MOD2022/0529

Designed by: Raise the Roof E info@raisetherooof.com.au Drawn by: Inlet Design Studio E robyn@inletdesign.com.au	REVISION: A DATE: 4/01/21 REVISION NOTE: Shadow date added	CLIENT: MR AND MRS BAKER ADDRESS: 26 Jeanette Ave Mona Vale	DRAWING: Site Plan and Site Analysis PROJECT: ALTERATIONS AND ADDITIONS PROJECT NO: JEA001 ISSUE TYPE: 2	DRAWN: RJ CHKD: RJ ISSUE DATE: 26/11/20	SHEET NO: A01 SCALE @ A3: 1:200 REVISION: B
	REVISION: B DATE: 09/09/22 REVISION NOTE: Ground Floor Roof design change Additional Balcony Roof, External stair Laundry addition

PROJECT:
ALTERATIONS AND ADDITIONS

DRAWING:
Proposed Ground Floor Plan

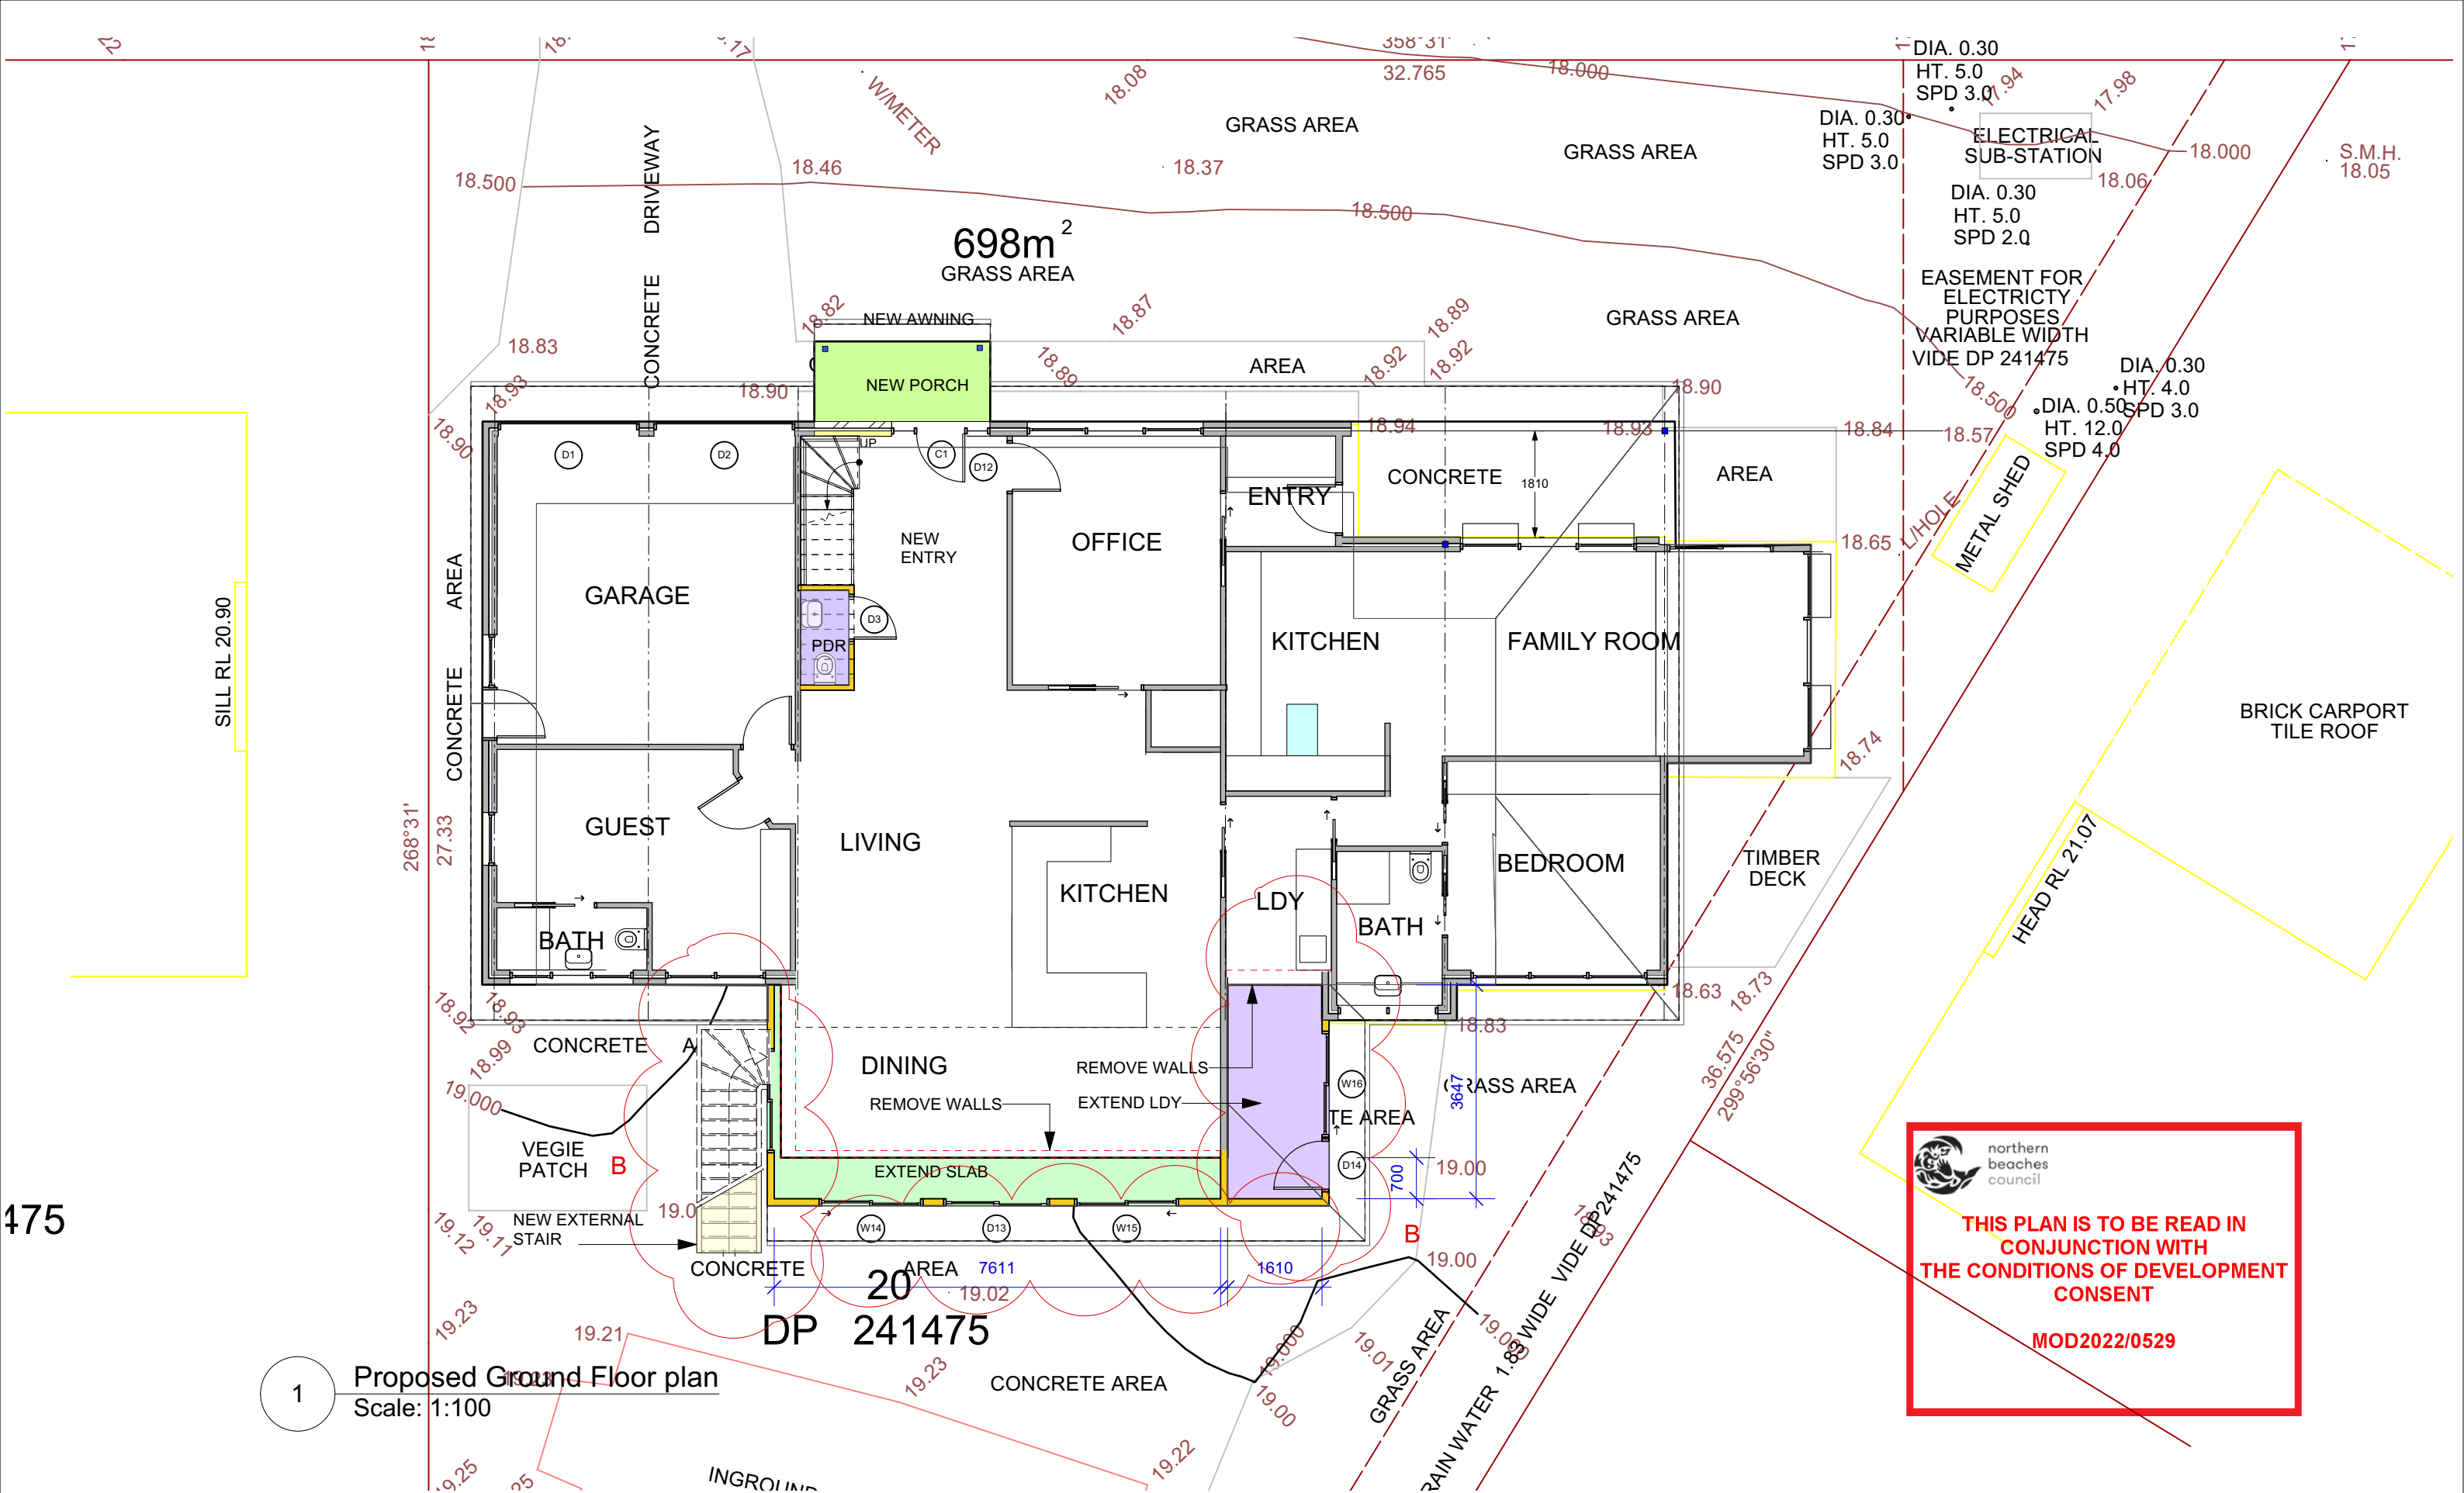
REVISION:	DATE:	REVISION NOTE:
A	4/01/21	Shadow date added
B	09/09/22	LAUNDRY ADDITION W16 & D14 added Eaves & External stair added

DRAWING:
WEST AND EAST ELEVATIONS

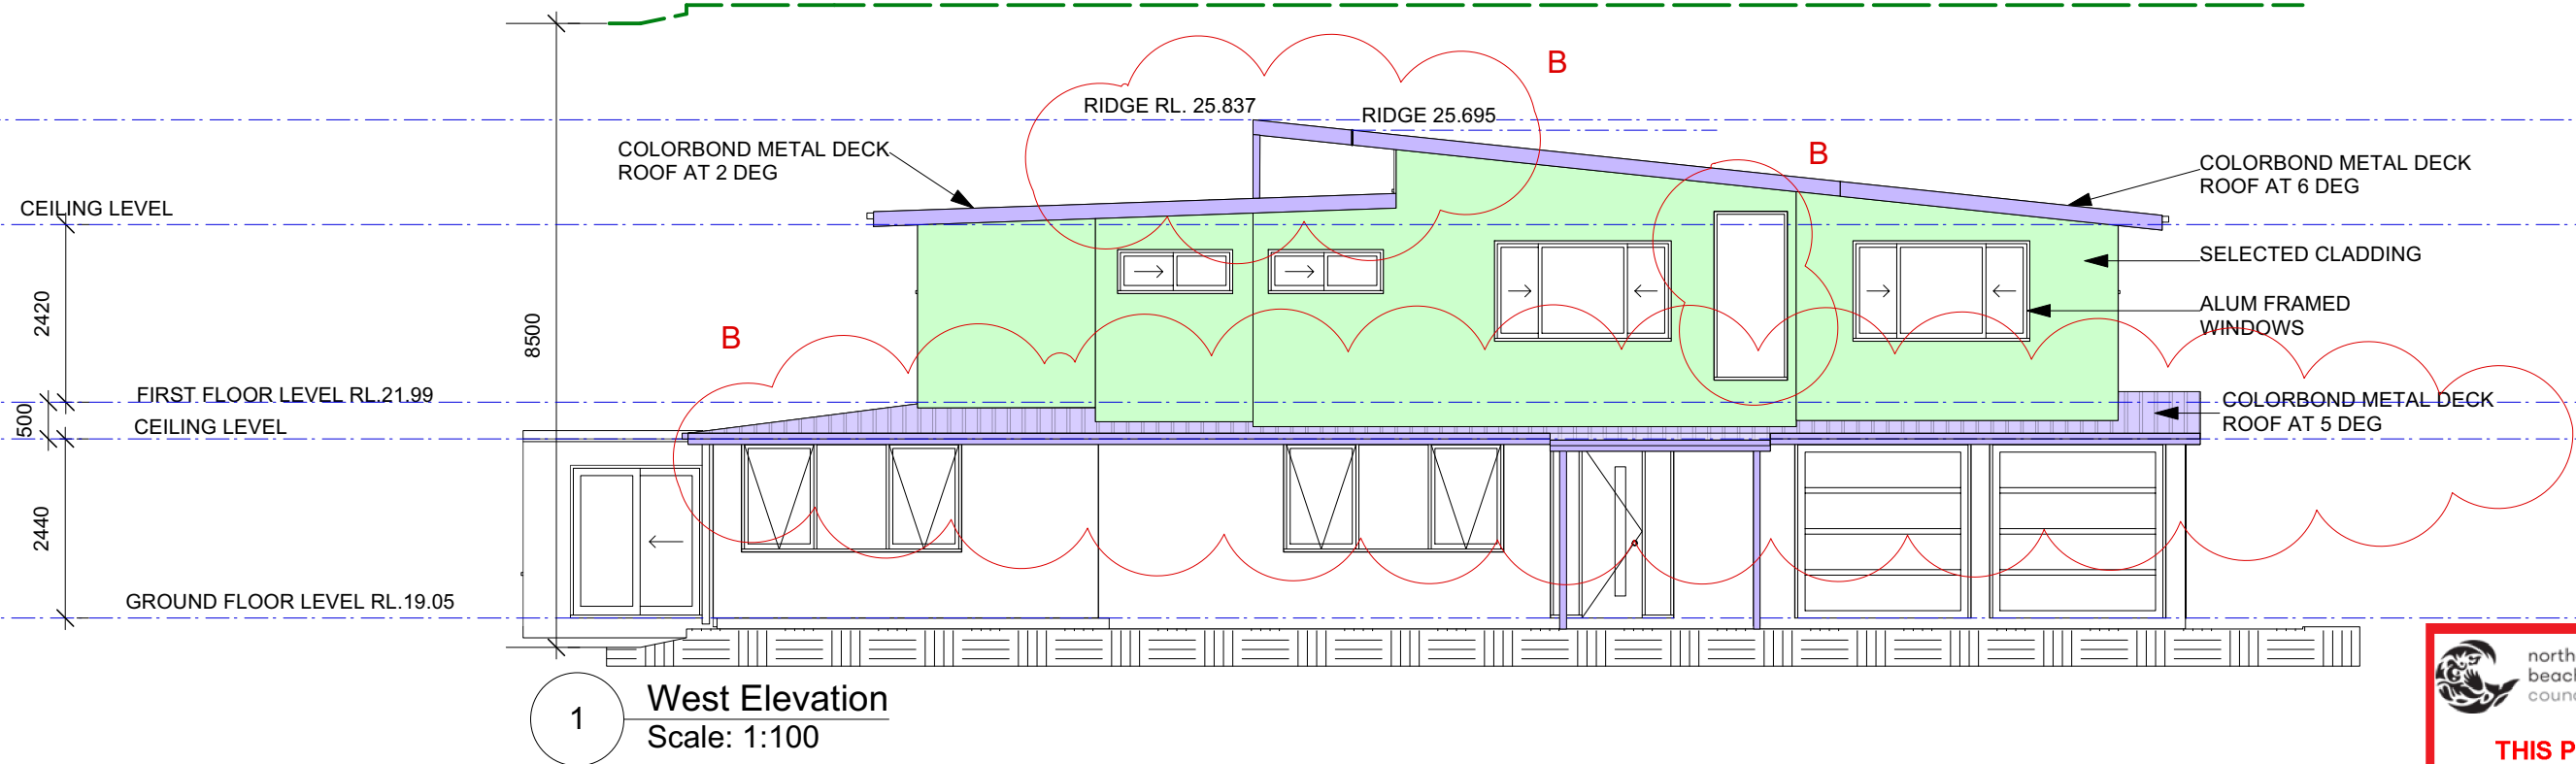
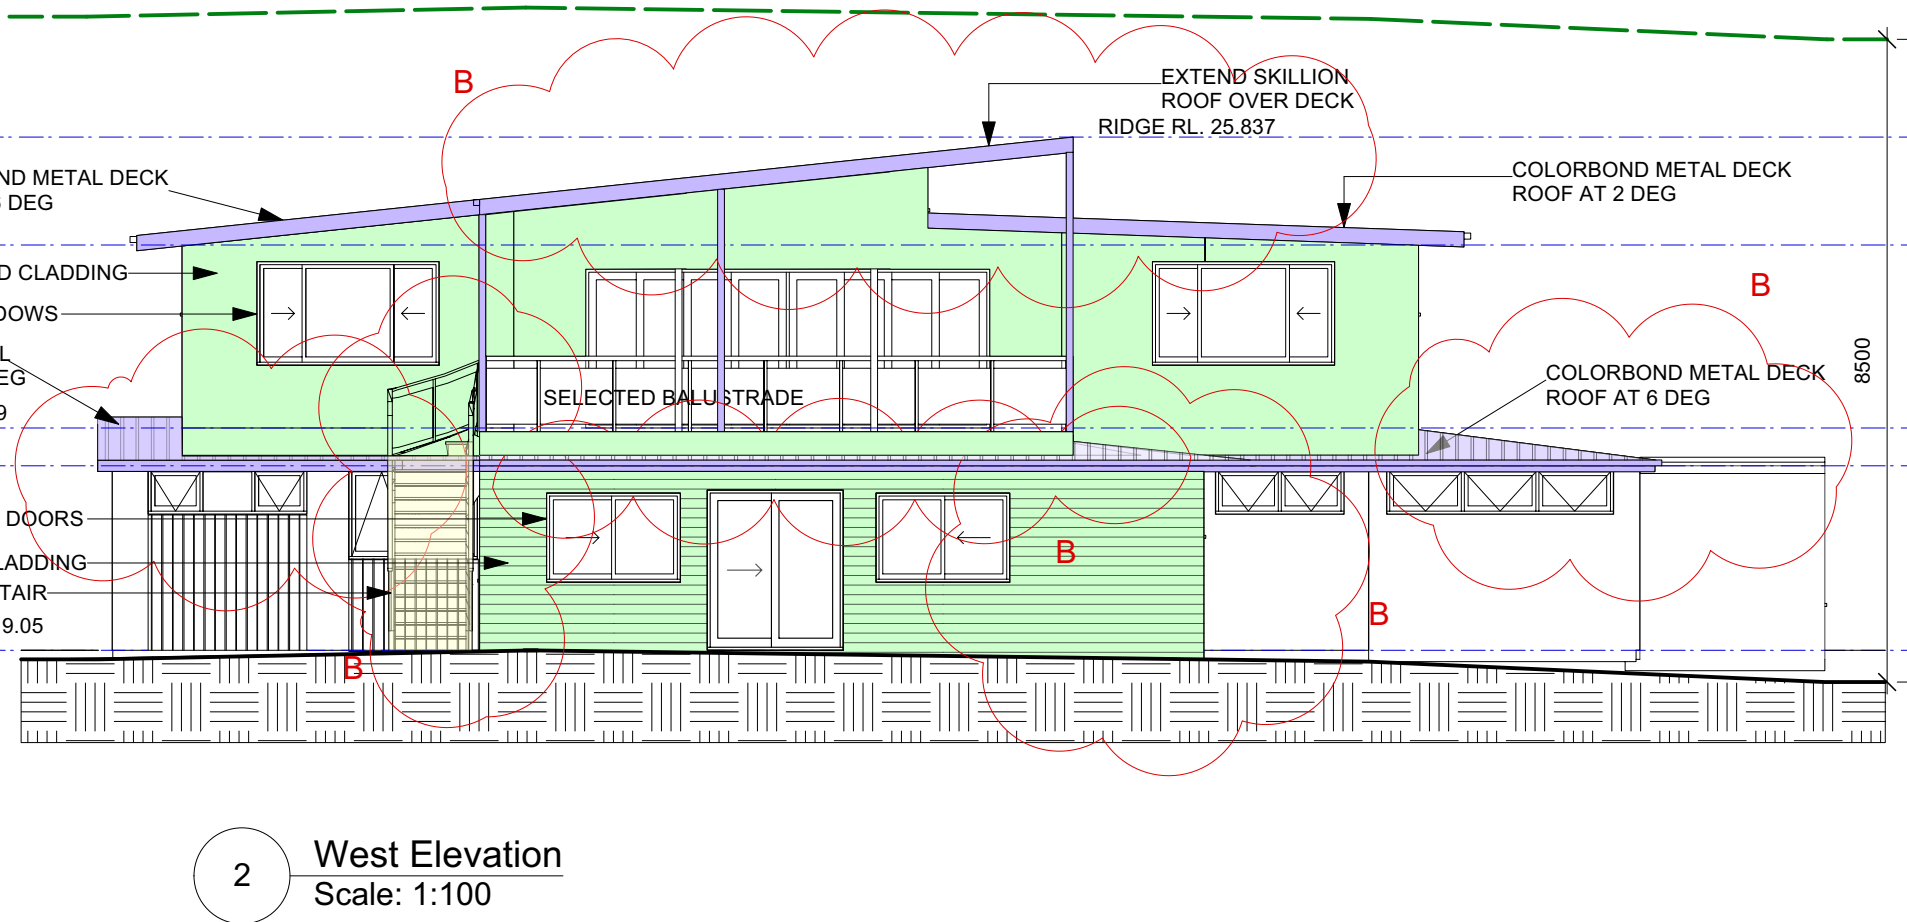
REVISION:	DATE:	REVISION NOTE:
A	4/01/21	Shadow date added
B	09/09/22	Ground Floor Roof design change Additional Balcony Roof Laundry addition, eaves added to ground floor W17 added

DRAWING: NORTH AND SOUTH ELEVATIONS	DRAWN: RJ	SHEET NO: A06
PROJECT: ALTERATIONS AND ADDITIONS	CHKD: RJ	SCALE @ A3: 1:100
PROJECT NO: JEA001	ISSUE TYPE: 1	ISSUE DATE: 26/11/20
		REVISION: B

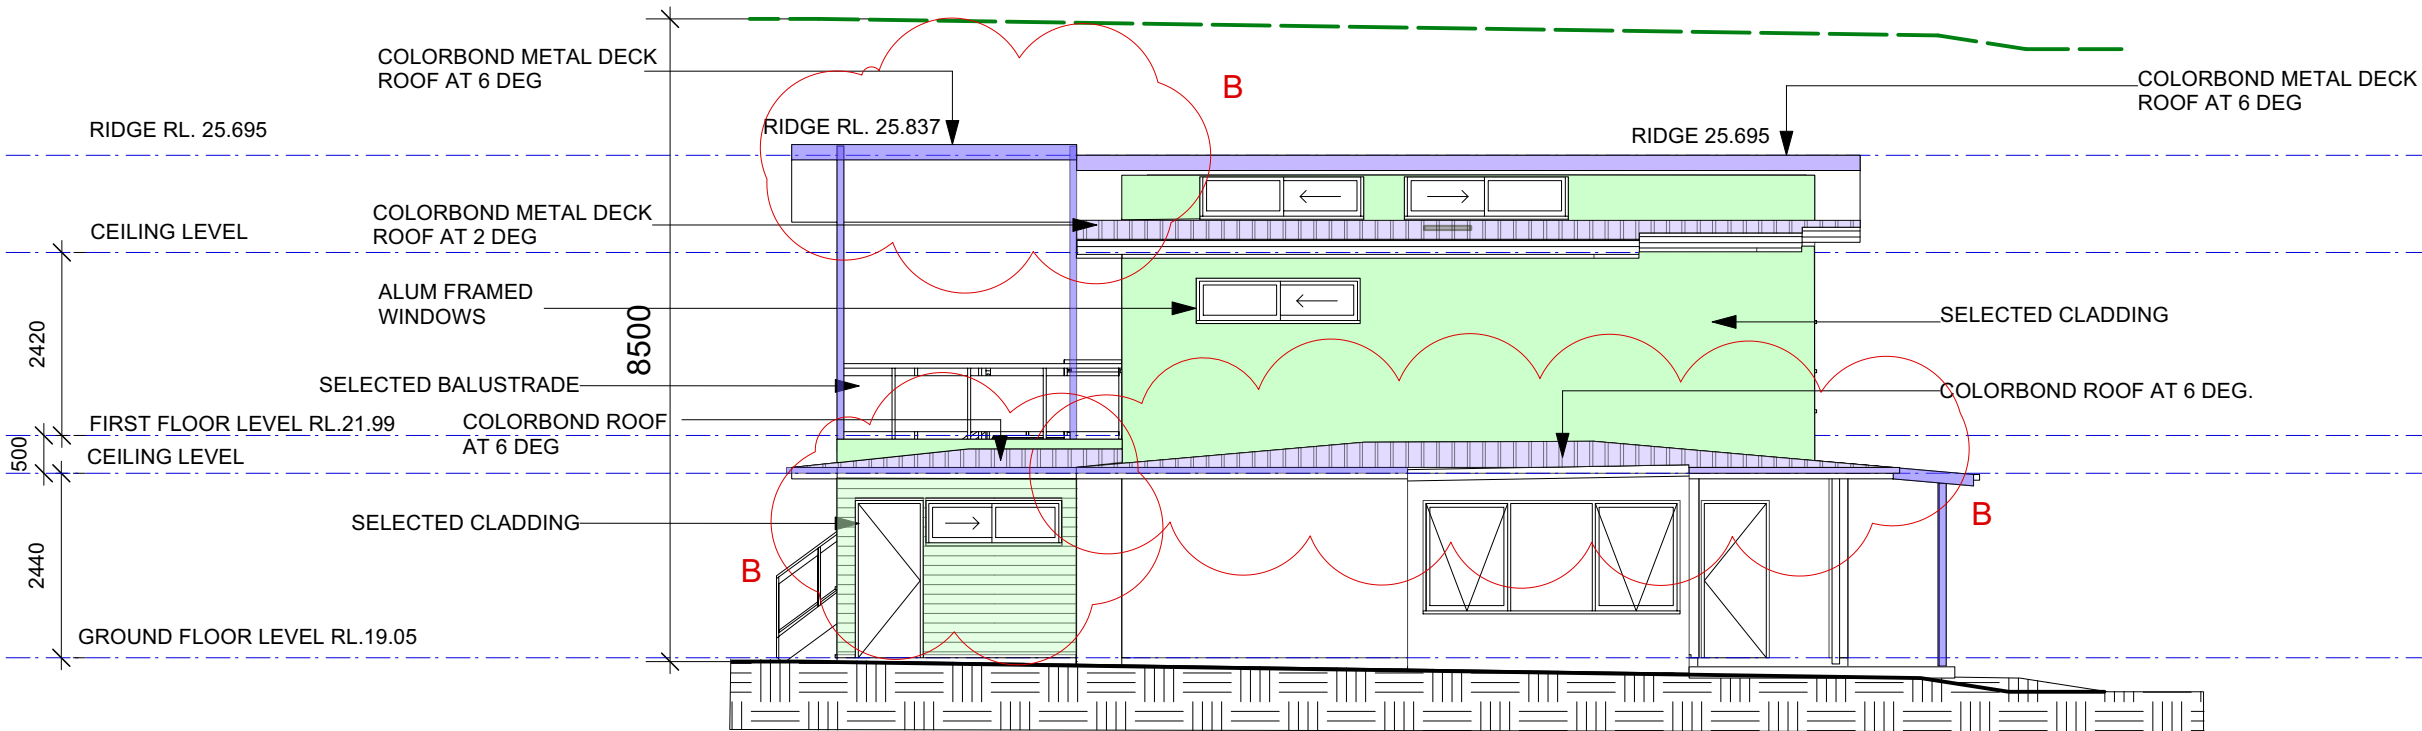
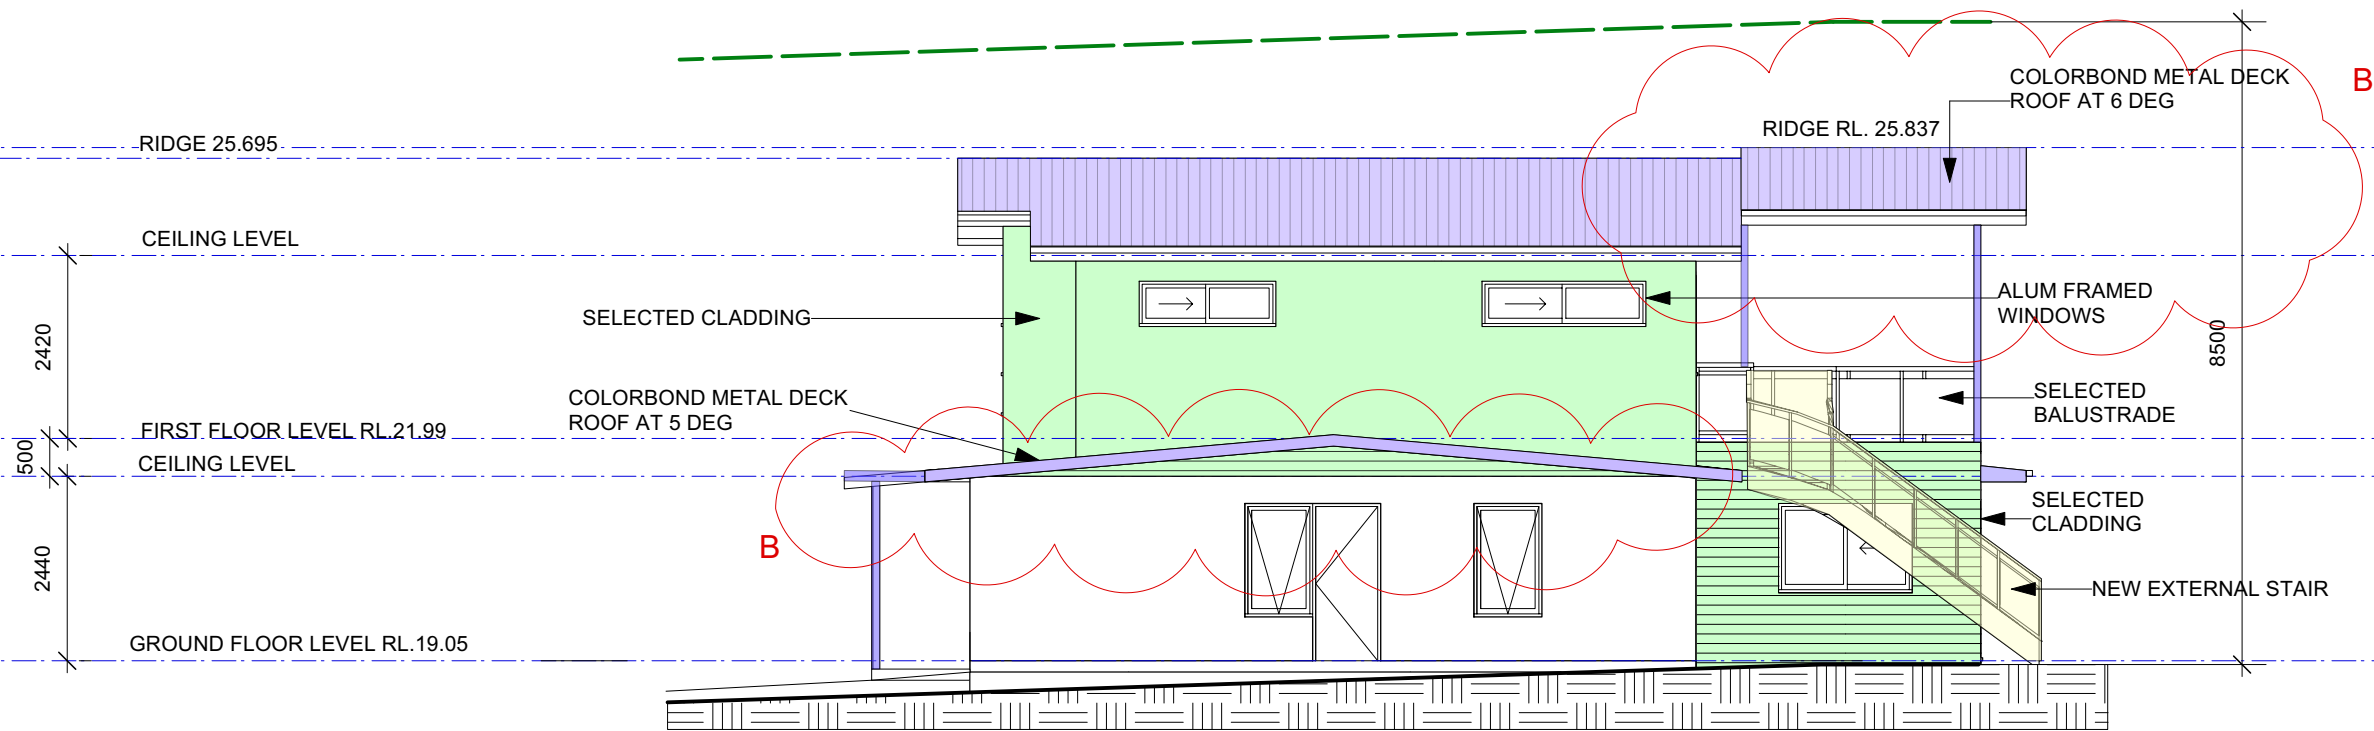
REVISION:	DATE:	REVISION NOTE:
A	4/01/21	Shadow date added
B	09/09/22	Ground Floor Roof design change Additional Balcony Roof Laundry addition
